Nature of Work: TEAR OFF SHAKE/INSTALL LIGHTWEIGHT TILE MONIER TILE W/ENG REPORT

SUBJECT: Reroof at 6806 Southland Park Drive, Sacramento, CA 95831

This letter is an addendum to my report of January 23rd 2003. In regards the following modification specification:

ROOF PLAN FOR
 6806 SOUTH LAND PARK DR
 SACRAMENTO, CA 95831

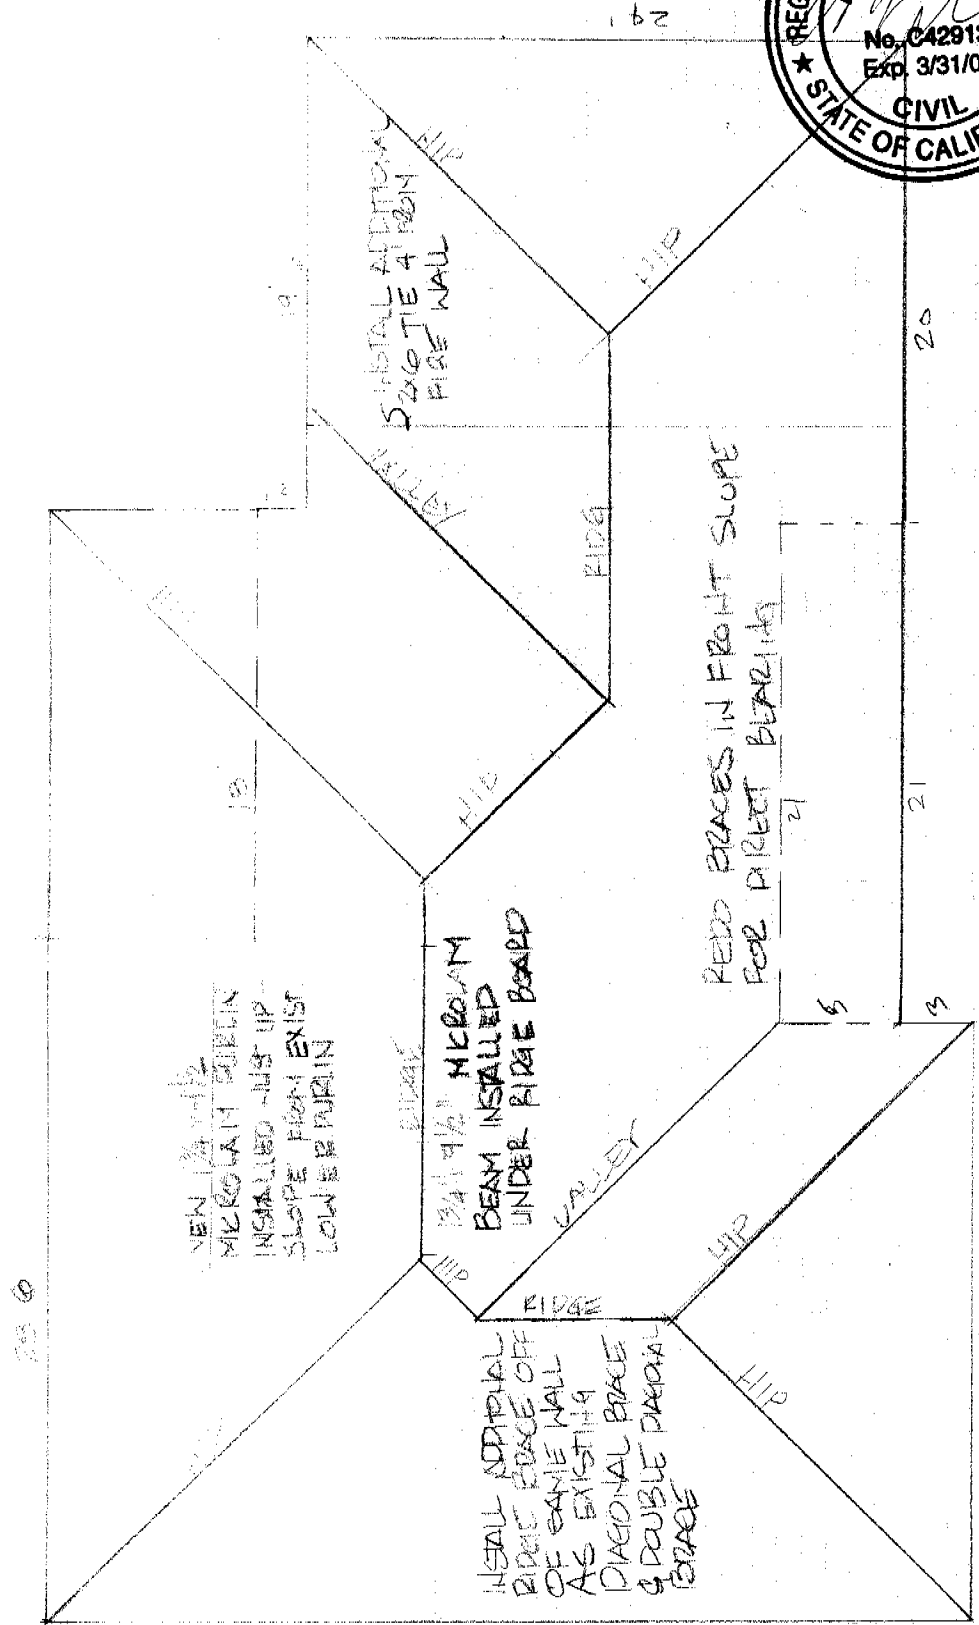
- * In the garage the rafter pair out 4' from the firewall should have a 2x6 tie installed at the plate level. The tie should be attached to the rafters with 5-16d nails. If it is spliced the splice should lap 4' and be attached with 5-16d nails(see attached sketch for details and plan for location).

- * In the bedroom wing install a vertical ridge brace off of the same wall that the diagonal ridge brace is installed off of. Also, the diagonal ridge brace should be doubled(see attached sketch for detail and plan for location).

- * In the front slope of the main wing of the house some of the purling braces are framed so as to run by the purlin and then rely on a block nailed to the brace to support the purlin. These are not adequate to support the roof loads and should be redone for direct bearing(see sketch for details and plan for location).

- * In the back slope of the main wing over the living room the lower purlin is not currently braced. A new 1-3/4"x 9-1/2" Microlam purlin should be installed just upslope from the existing purlin. Also the ridge over the living room should be supported by a 1-3/4"/9-1/2" Microlam. Both of these Microlams should be braced off of the side walls of the living room(see sketch for location and sketch for details).
